ADDENDUM NO. 01

**Franklin Central High School Addition & Renovations
6215 S. Franklin Rd.
Indianapolis, IN, 46259**

ADDENDUM NO. 1 (ONE)

DATE: January 31, 2023
PROJECT: Addition & Renovations to Franklin Central High School
OWNER: Franklin Township Community School Corporation
PROJECT NO.: 2022043.00

4 EXTERIOR LIGHTING AND CONTROLS

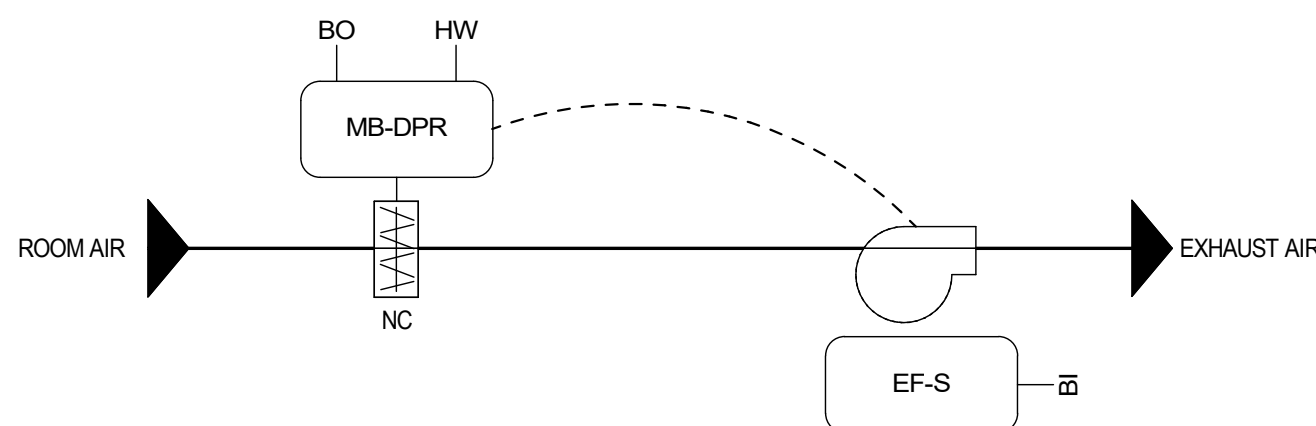
THE BMS SHALL BE INTEGRATED TO THE EXTERIOR LIGHTING CONTROLS AND SHALL PROVIDE A DRY CONTACT, WIRING TO THE LIGHTING PANEL AND LOGIC TO CONTROL THE EXTERIOR LIGHTING AS FOLLOWS (SEE SPECIFICATION SECTION 230600 FOR ADDITIONAL INFORMATION):

- 1) ENERGIZE AT DUSK
- 2) DE-ENERGIZE AT DAWN
